Service Bulletin

Bulletin No.: 16-NA-185

Subject: Information on Front Lower Air Dam

Brand:	Model:	Model Year:		VIN:		Engine:	Transmission:
		from	to	from	to		
Buick	Cascada	2016	2016			All	All

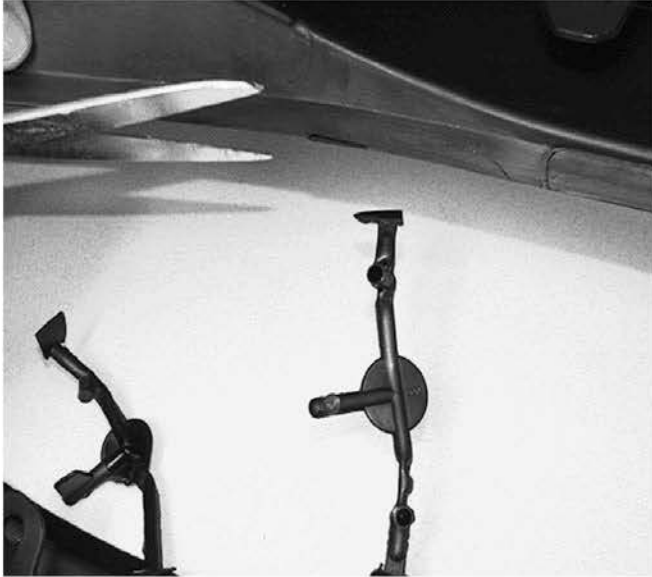
Condition	The two piece front lower air dams are placed in the vehicles trunk at the assembly plant and installed at the dealership during PDI. They were originally separate left and right side parts, but dealers will begin seeing the two halves connected.
Cause	 <p>4498061</p> <p>As an error-proofing measure to ensure the left and right halves arrive properly, the two pieces now are attached to each other.</p>

Before installation of the air dam, it will now be necessary to cut the two halves apart, removing the excess plastic.

Using scissors, or a similar cutting tool, cut the six flat tabs at the part edge and trim any excess plastic as close to the edge as possible.
